V2500-A1/A5/D5 SERIES PROPULSION SYSTEMS SERVICE BULLETIN

V2500-ENG-80-0014

STARTING - PNEUMATIC STARTER - INTRODUCTION OF REVISED STARTER WITH MODIFIED TURBINE
RETENTION NUT PRE-LOAD

PNEUMATIC STARTER - REPLACEMENT OF THE TURBINE ROTOR RETENTION NUT AND REWORK OF THE PINION GEAR

Figure 1. Rework of the Rotor Pinion

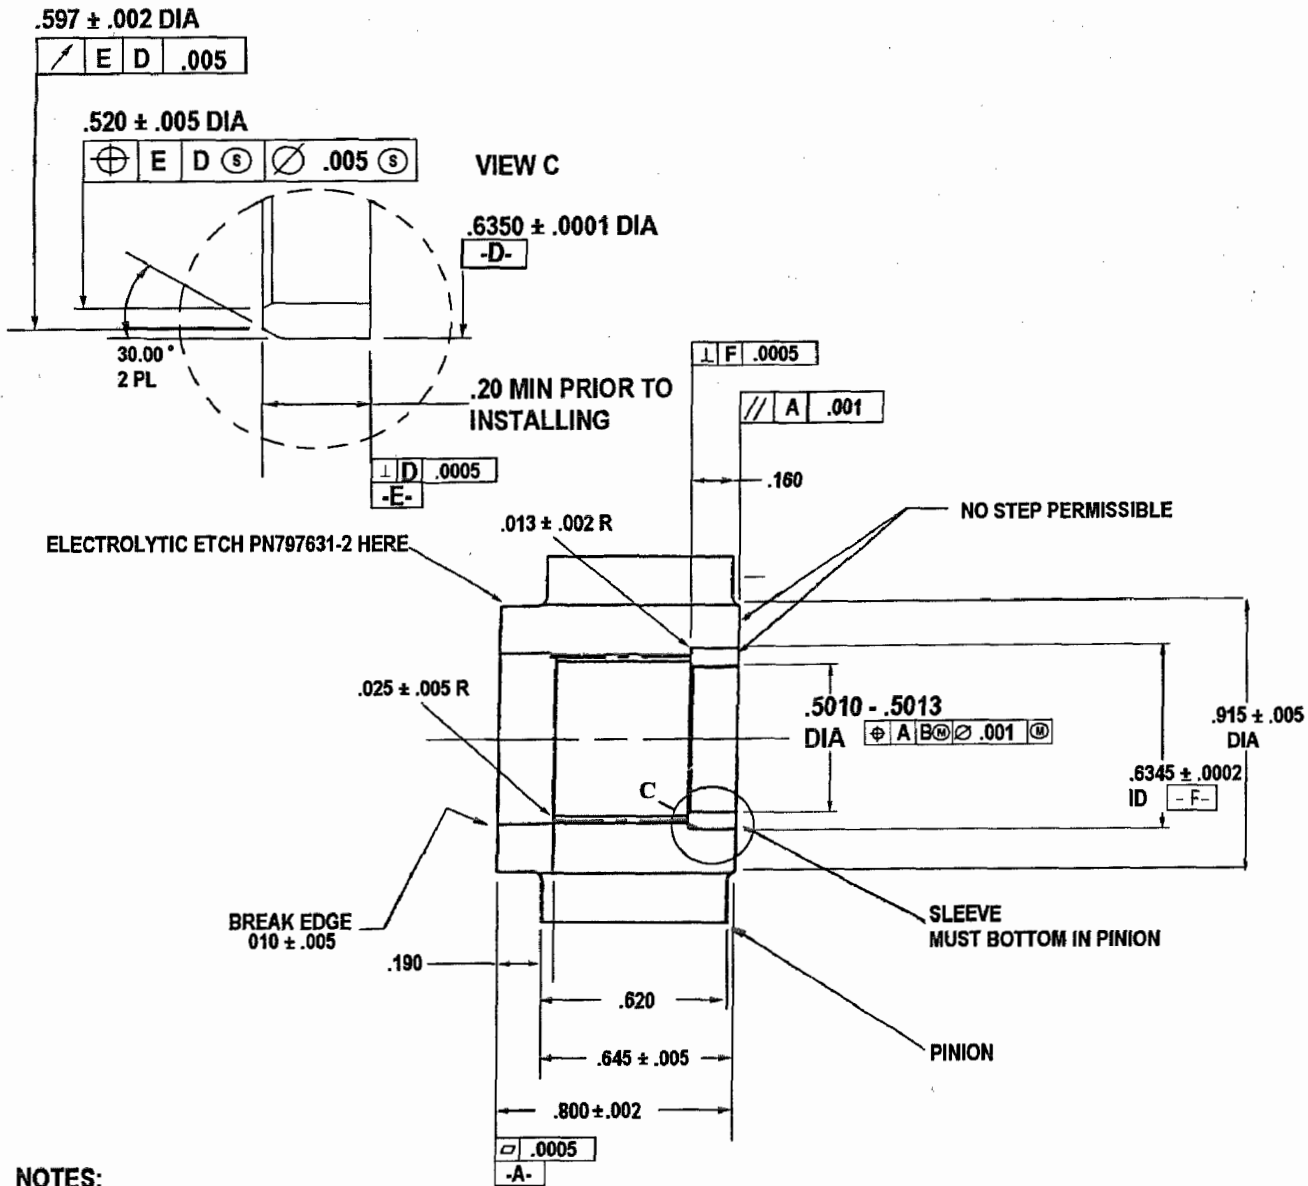
- C. The rotor pinion may be reworked from PN 797631-1 to PN 797631-2. To rework the rotor pinion, do these steps:

(1) Machine the pinion to the requirements shown in Figure 1.

2. SLEEVE MAT'L: AMS6415 OR MIL-S-5000; HARDNESS 36-40HRC;
HEAT TREAT PER MIL-H-6875

- (2) Install the sleeve PN 797631-21 in the pinion. Press the sleeve into place using 1000 ± 100 lbs. axial force and make sure that it bottoms in the pinion gear.
- (3) Finish machine the pinion and sleeve to the requirements shown in Figure 1. No steps are permissible.
- (4) Reidentify the rotor pinion PN 797631-1 to PN 797631-2 as given below:

- 1 Electrolytic etch the PN "797631-2" onto the surface as shown in Figure 1.

Figure 2. Shim Rotor Balancing Assembly/Install Pin

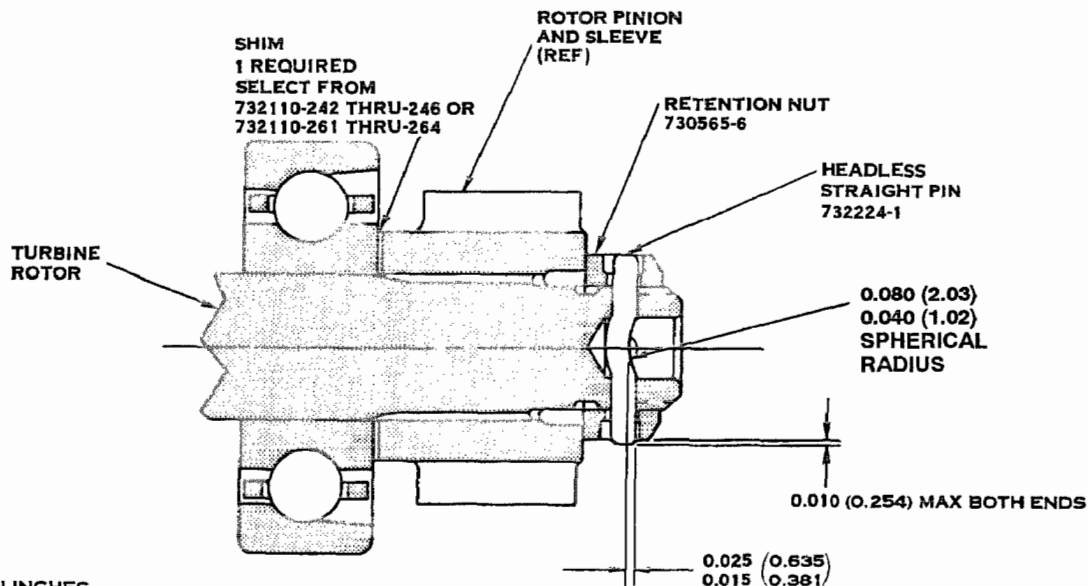
- (1) Refer to Figure 2. Assemble the shim PN 732110-264, the rotor pinion and sleeve PN 797631-2, the retention nut PN 730565-6, and the headless straight pin PN 732224-1 with the steps that follow:
 - (a) Install one 0.021inch (0.53 mm) thick solid shim PN 732110-264 on the turbine rotor PN 792937-5 against the ball bearing PN 797647-1.

- (b) Apply lubricating oil, MIL-L-23699 or MIL-L-7808 on the internal splines of the rotor pinion and sleeve PN 797631-2, the external splines of the rotor shaft PN 792937-5.
 - (c) Align the internal splines of the rotor pinion and sleeve PN 797631-2 and the external splines of the rotor shaft.
 - (d) Use a thin film of Ultrachem assembly fluid #1 (national stock number 9150-00-159-5012) available from UltraChem, Inc. Wilmington DE Cage Code 2H317, as a thread lubricant. Coat the threads of the turbine rotor shaft PN 792937-5, the retention nut PN 730565-6 and the load bearing face of the retention nut and mating face of pinion PN 797631-2 with a thin film of Ultrachem.

- (e) Load pinion spline to rotor spline in a counterclockwise direction when looking at the nut.
 - (f) Apply initial nut torque of 360 - 375 in-lbs.
 - (g) Loosen nut to 0 in-lbs

- (h) Re-torque the nut with the pinion spline loaded to rotor spline in a counterclockwise direction, apply initial nut torque of 50 - 60 inch lbs.

Figure 3.
Pin Alignment

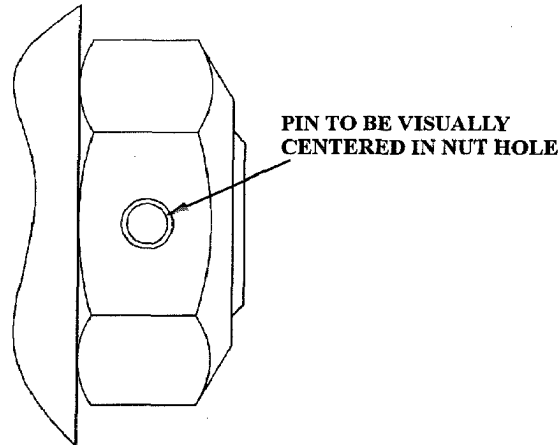
- (n) If the hole in the retention nut PN 730565-6 is aligned with the hole in the rotor shaft PN 792937-5, install the headless straight pin PN 732224-1 per Figure 3. If the pin is centered in the hole in the retention nut PN 730565-6 as shown in Figure 3, go to the **ASSEMBLY** section of the CMM and balance the rotor assembly and deform the headless straight pin PN 732224-1 per the CMM.
- (o) If the headless straight pin PN 732224-1 cannot be installed as shown in Figure 3, use the steps that follow to align the hole in the shaft with the hole in the nut.

- I** The final angle of the nut shall be 44° to 54° from the zero point which is located when the nut has 50 to 60 inch pounds of torque on it. The headless straight pin PN 732224-1 must be centered in the hole in the retention nut PN 730565-6 as shown in Figure 3.
